UNITED STATES PATENT AND TRADEMARK OFFICE

APPLICATION NO.	FILING DATE	FIRST NAMED INVENTOR	ATTORNEY DOCKET NO.	CONFIRMATION NO.
10/656,138	09/08/2003	Kimikazu Matsumoto	8005-1006-1	8662
466	7590	06/14/2005	EXAMINER	
YOUNG & THOMPSON 745 SOUTH 23RD STREET 2ND FLOOR ARLINGTON, VA 22202			NGO, HUYEN LE	
			ART UNIT	PAPER NUMBER
			2871

Office Action Summary	Application No. 10/656,138	Applicant(s) MATSUMOTO ET AL.	
	Examiner Julie-Huyen L. Ngo	Art Unit 2871

FIG. 11

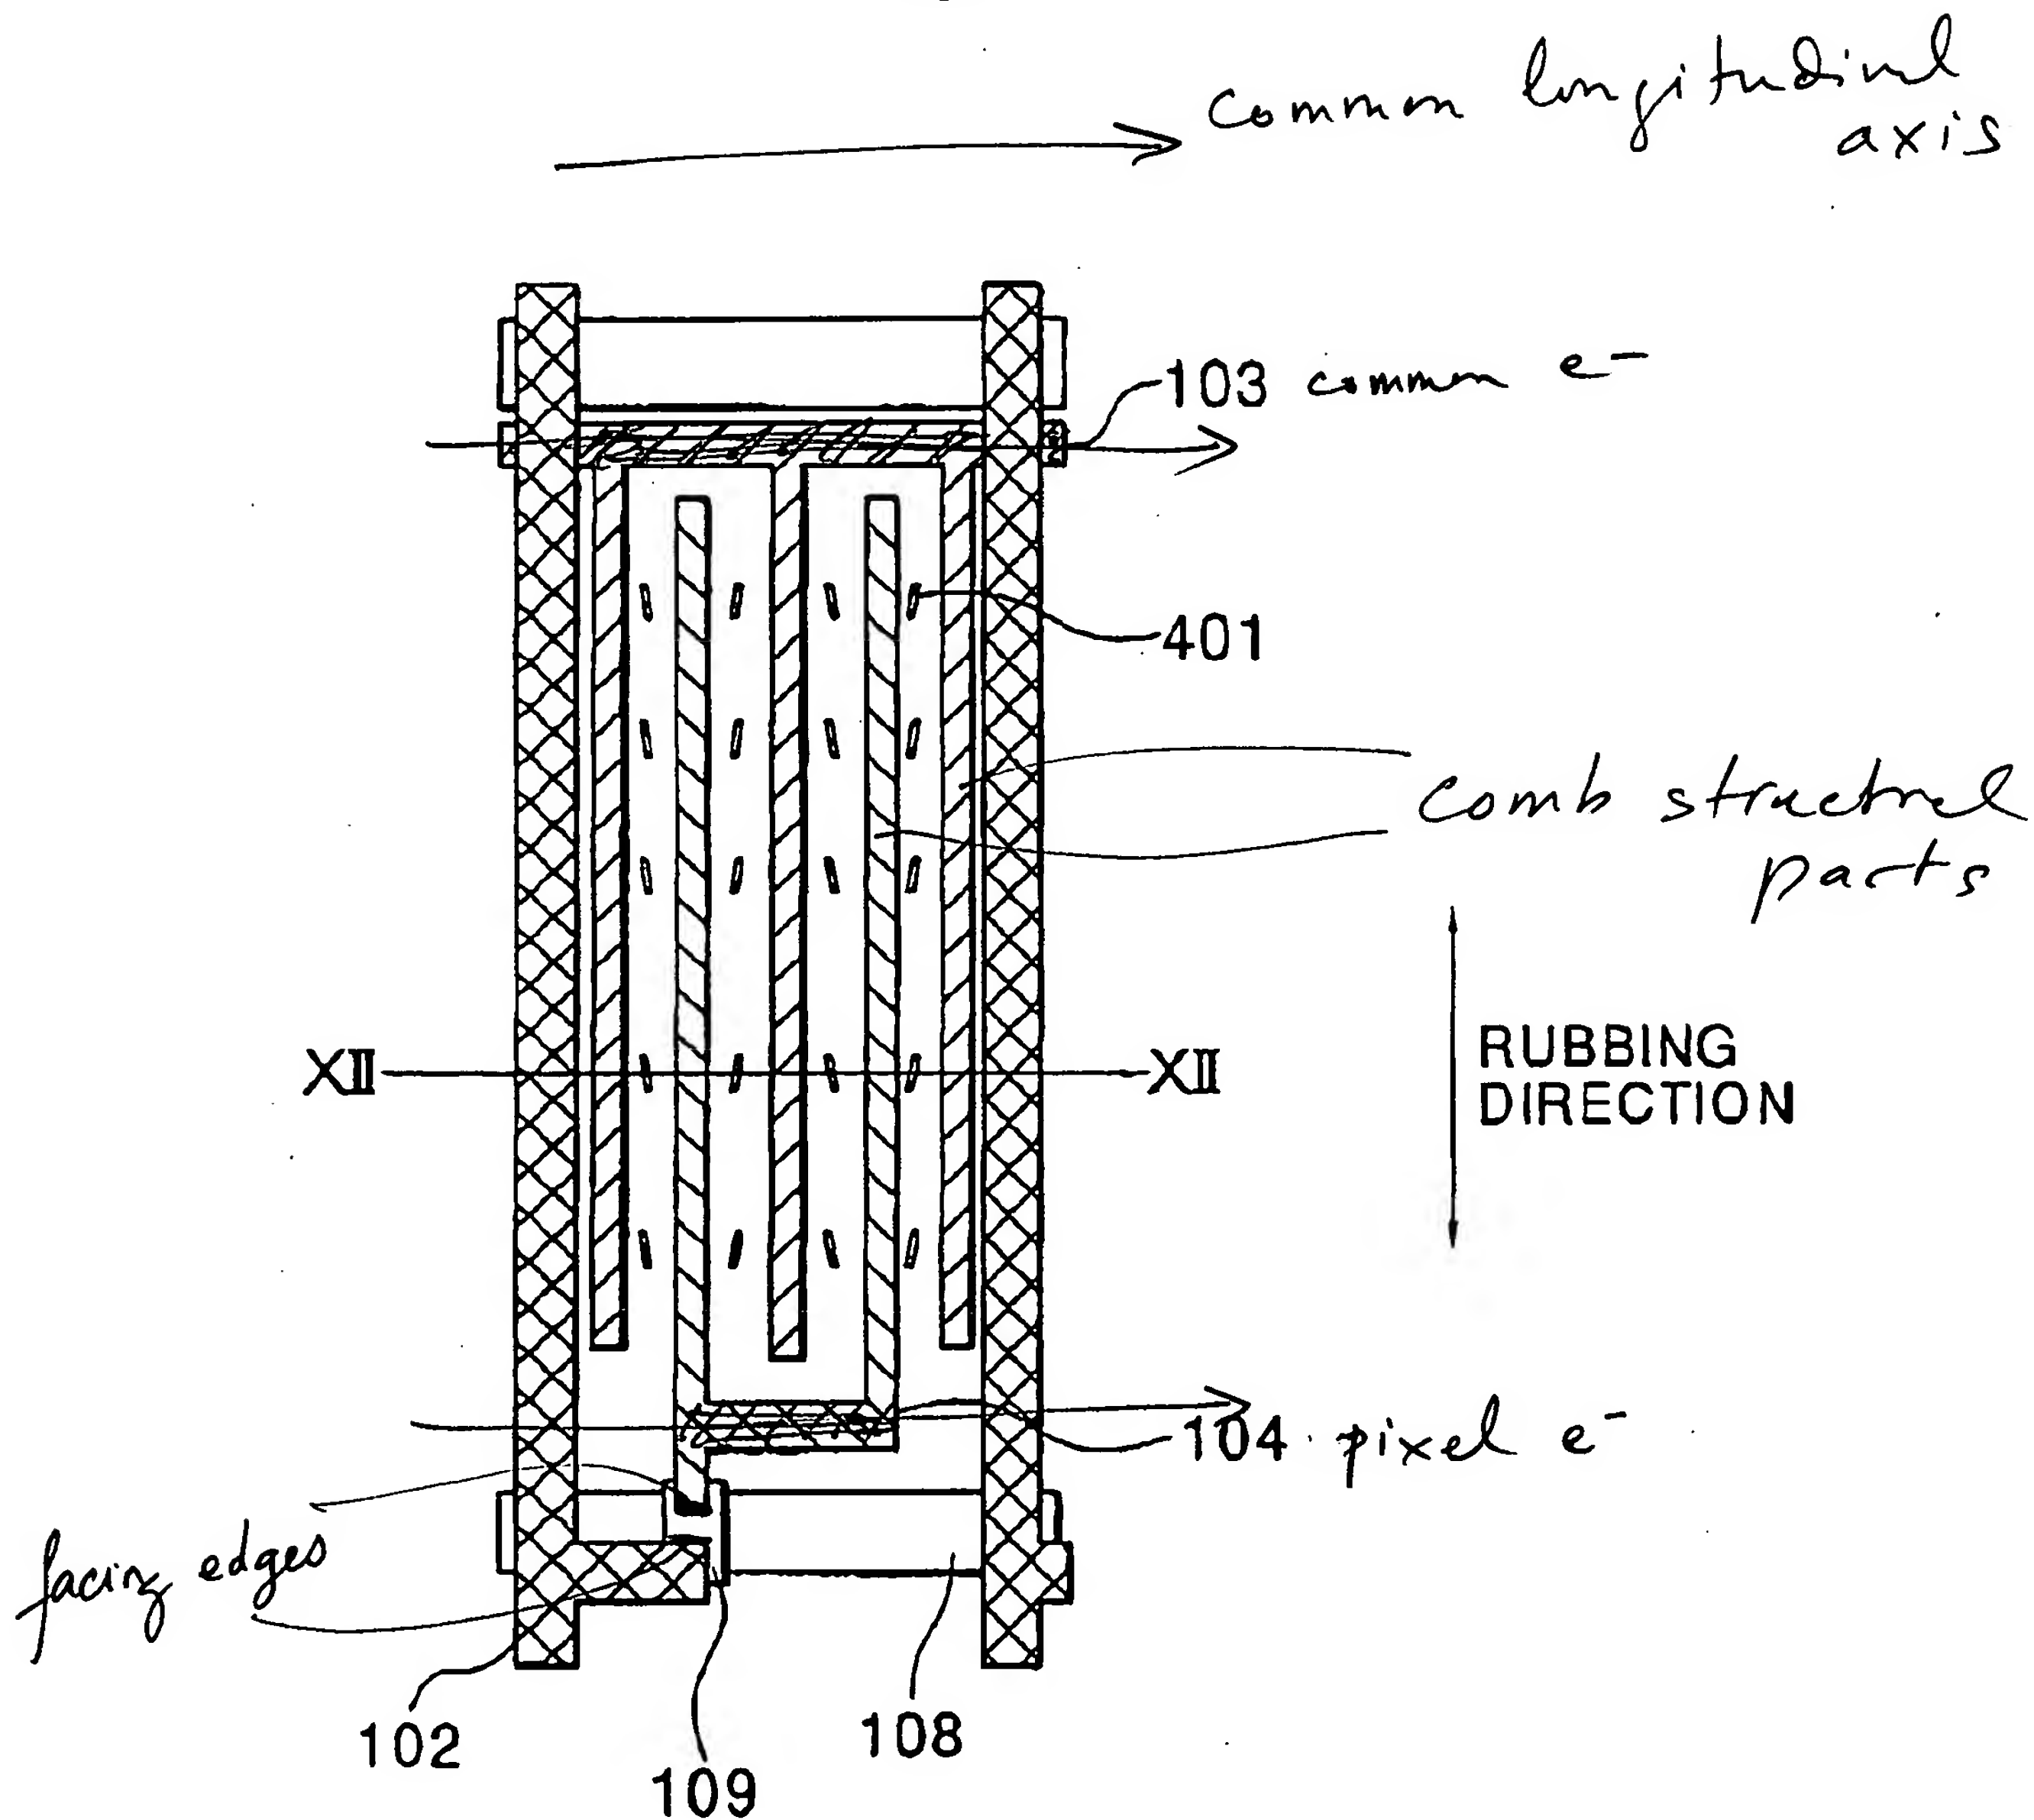
Watanabe et al. teach (Fig. 11) forming an active matrix liquid crystal display device comprising:

- a pair of substrates 101/201 with a liquid crystal layer 301 between said substrates;
- a pixel electrode 104 and a common electrode 103 having a common longitudinal axis and that are arranged and adapted to generate an electric field parallel to said substrates in said liquid crystal layer, said liquid crystal layer having a nonzero initial alignment angle of 90 degrees relative to the common longitudinal axis;
- a thin film transistor having a source electrode and a drain electrode adjacent to a first part of said liquid crystal layer under protective layer 106, said source and drain electrodes inherently being arranged and adapted so that an electric field

- said source and drain electrodes are arranged and adapted so that an electric field generated between said source and drain electrodes is substantially parallel to the non-zero initial alignment angle, and wherein said source and drain electrodes have facing edges that are parallel to each other and perpendicular to the non-zero-initial alignment angle as Fig. 11 shown.

WATANABE et al. disclose that the common electrode and pixel electrode have two parts: one part of electrode 103/104 is parallel to gate lines 108 and the other part of said electrode (comb structures) is parallel to data lines 102. Therefore, the initial alignment angle in WATANABE et al. is 90° (not zero) relative to the common longitudinal axis, and the source and drain electrodes have facing edges that are parallel to each other and perpendicular to the non-zero-initial alignment angle (see attachment 1).

FIG. 4

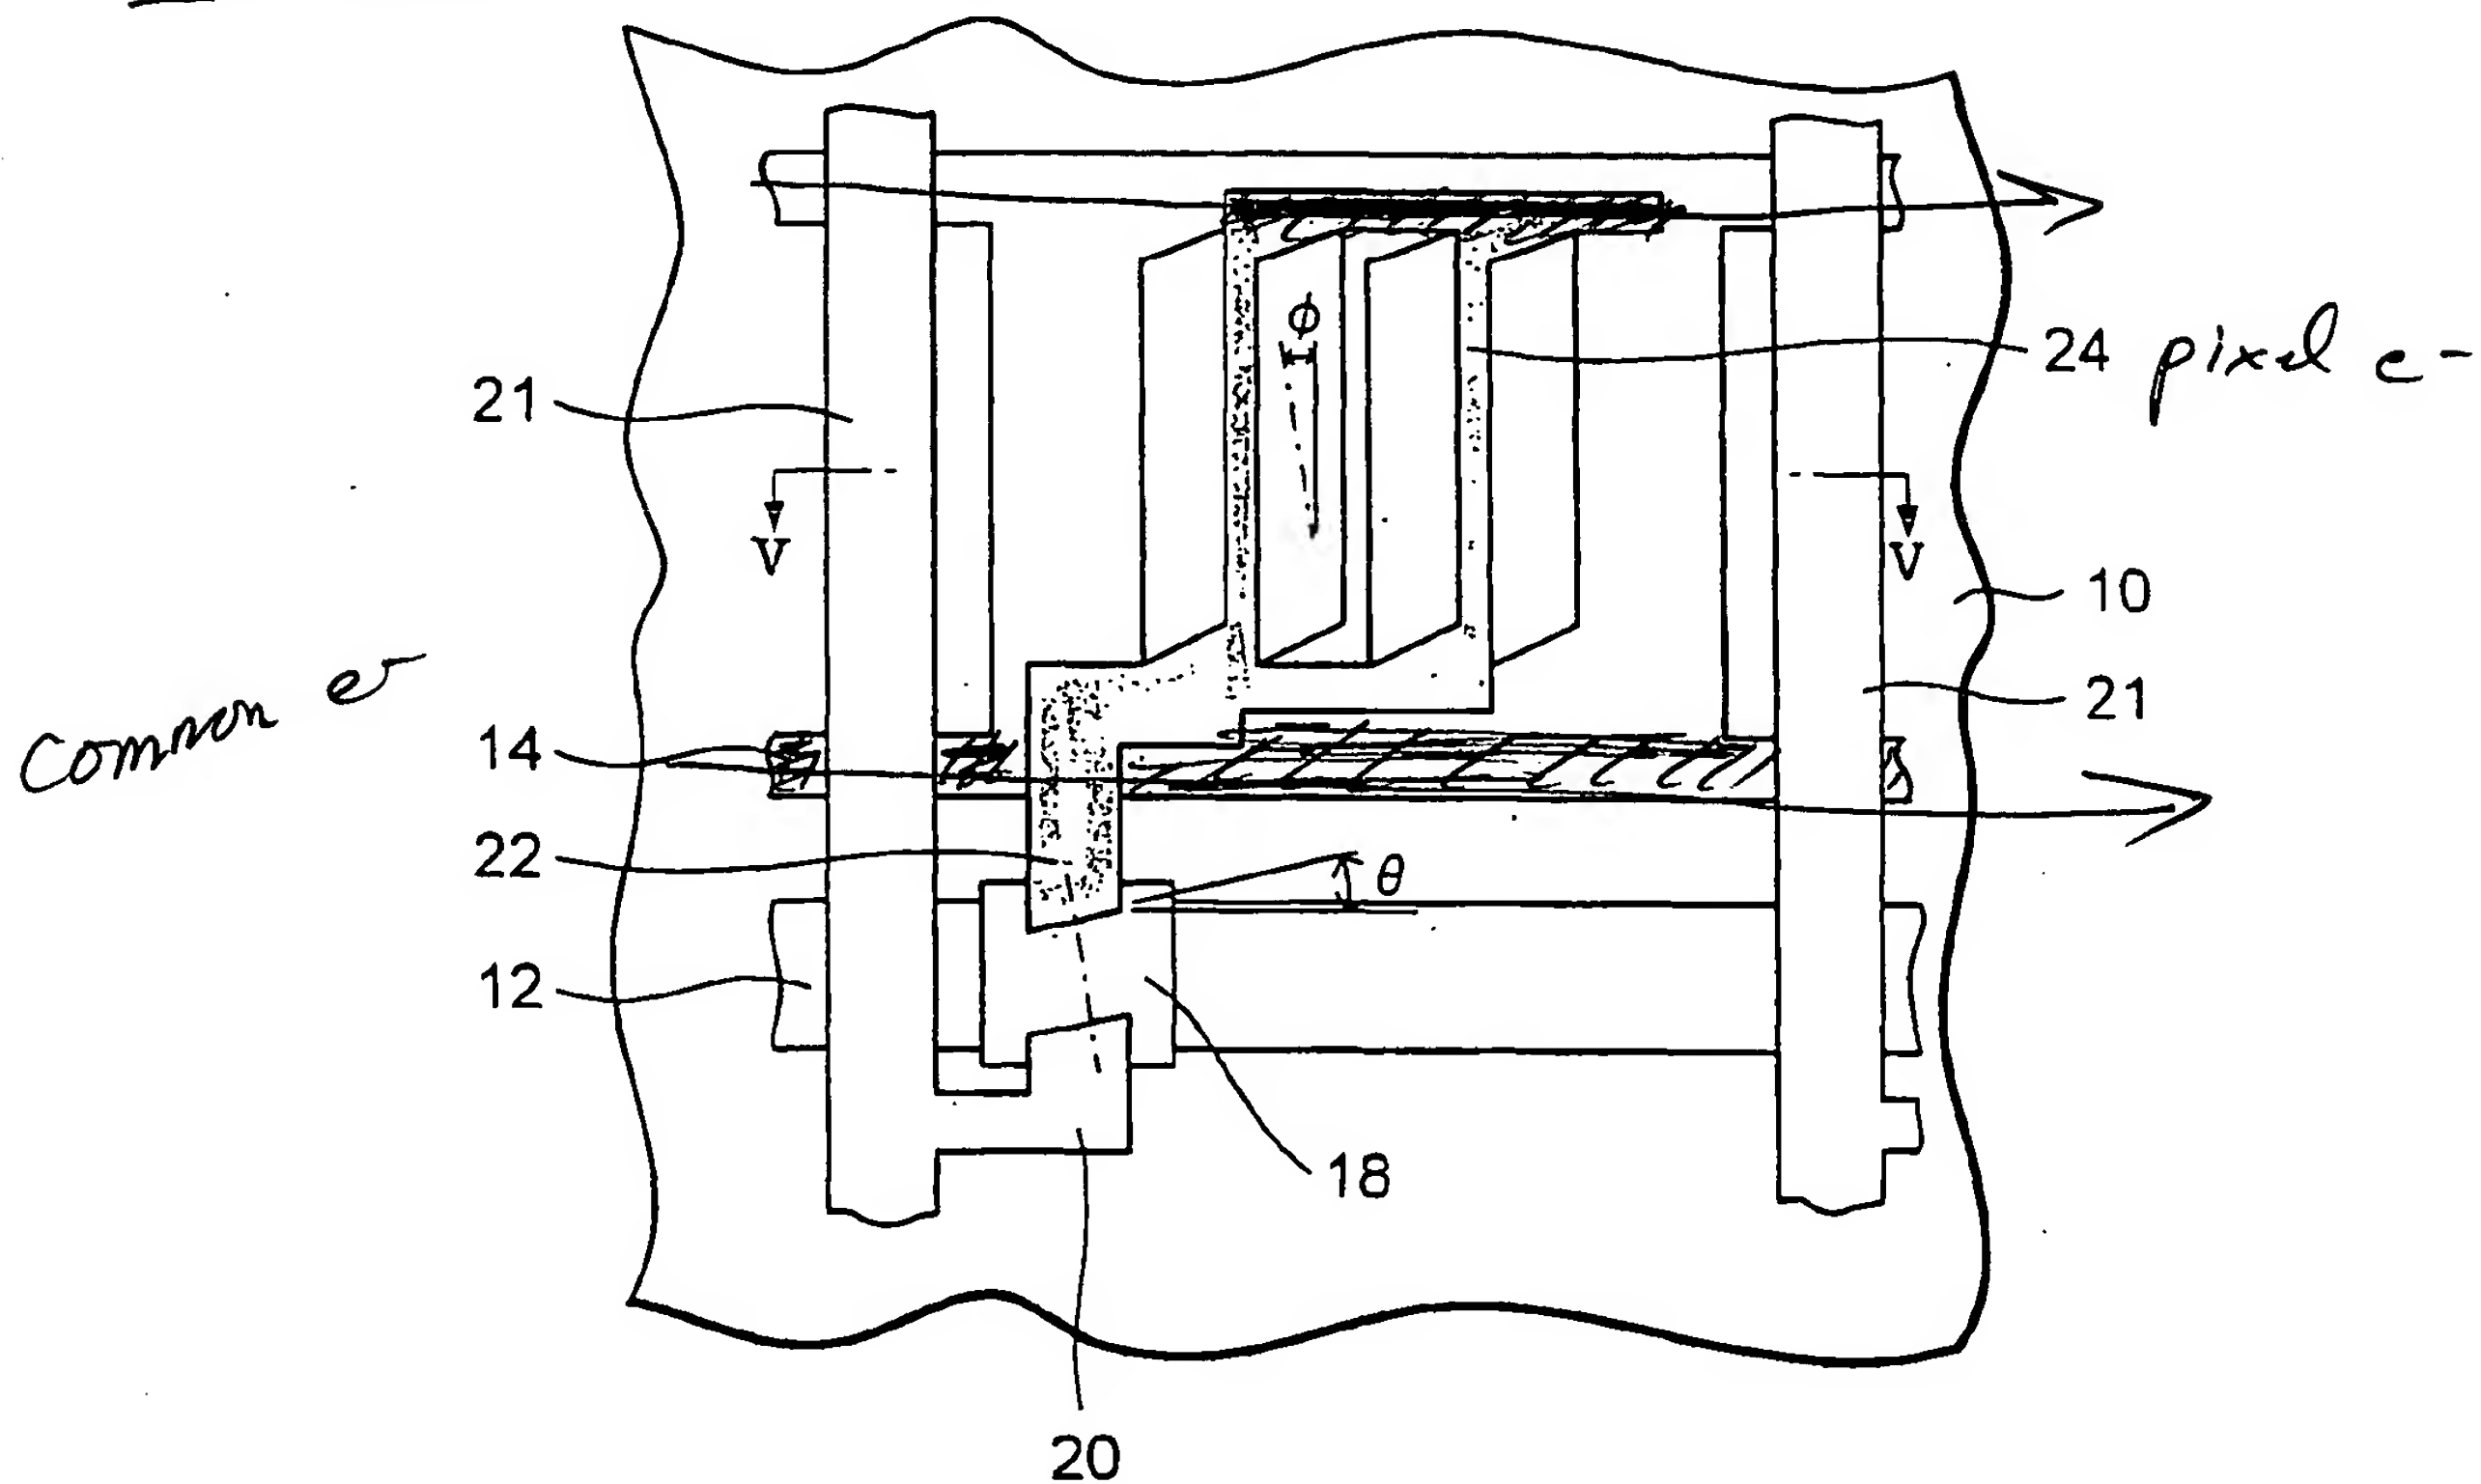
Applicant is to note in Figure 4 of the present application, that the common electrode 14 and pixel electrode 24 have two parts: one part of the electrodes is parallel to gate lines 12 and other part of the electrodes (comb structures) is parallel to data lines 21. The common electrode 14 (not comb-structure parts) and pixel electrode (comb-structure parts) 24 do not have a common longitudinal axis (see attachment 2).
